# UNITED STATES PATENT AND TRADEMARK OFFICE

APPLICATION NO.	FILING DATE	FIRST NAMED INVENTOR	ATTORNEY DOCKET NO.	CONFIRMATION NO.
09/965,990	09/28/2001	Jerry L. Carlson	98-HSP-245	4857

# Office Action Summary

## **DETAILED ACTION**

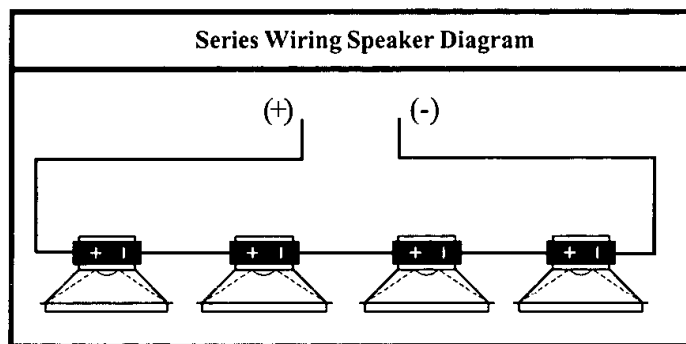
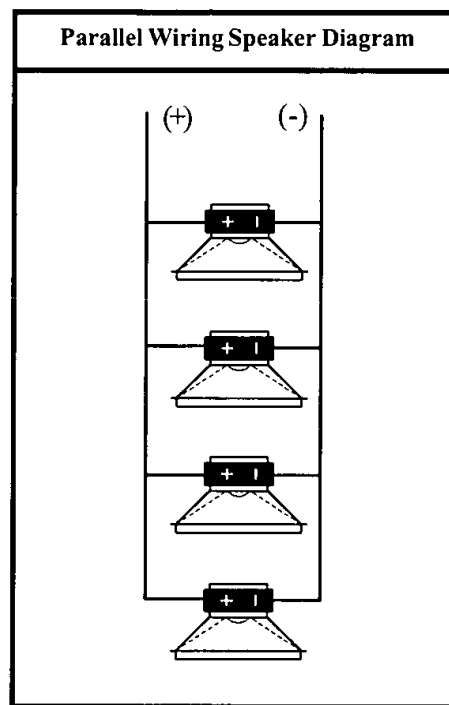
Re: claim 1, line 9, "a filter assembly disposed in series flow relationship" is inaccurate because disclosed filter assembly is in a parallel arrangement (see attachment).

9. The applicant argues “it can be seen clearly from the schematic of fig. 2 that in fact the filter assembly (81) is in a series flow relationship between the source of fluid C and the various outlets and inlets (63 and 65),” which is not claimed. The claim sets forth “a filter assembly disposed in series flow relationship in said flow path,” the claim further sets forth “said flow path including in order, said source, said pump inlet, said pump outlet, said motor inlet, and said motor outlet.” The filter assembly, however, clearly is in a parallel relationship in said flow path. Included in the action is a schematic of series and parallel relationships, as exhibit A. The illustrations in exhibit A show parallel and series diagrams. Since the oil in the instant invention is allowed to flow in more than one flow path, it is not defined as a series relationship. Until oil

is lost in the system no oil will enter from the source and the filter, because this is the case oil will not be filtered between motor and pump each and every time during operation, thus it is in a parallel relationship.
